## Product Change Notification

## Changes to Bourns® Model 7100 Series Common Mode Chokes

Bourns is announcing the following changes to the [Model 7100 Series](#) Common Mode Chokes.

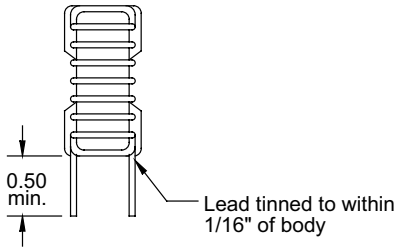
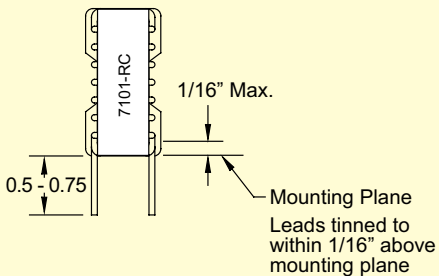
- 1) **Manufacturing Location:** Production is being transferred from China to Honduras to help streamline the production process.
- 2) **Materials:** The magnetic wire insulation thermal class will be upgraded. Other materials will be adjusted accordingly, as well. For your convenience, Table 1 lists the change.
- 3) **Product Specifications:** The marking, terminal lead tinning specification/lead length and component dimension will be modified. For your convenience, Table 2 and 3 list the details.
- 4) **MOQ/Mult:** The Minimum Order Quantity (MOQ) / Multiples quantity (Mult) will be affected. Table 4 lists the changes.

The form and fit of the product will be changing; however, there will be no change to the function, quality or the reliability of the product.
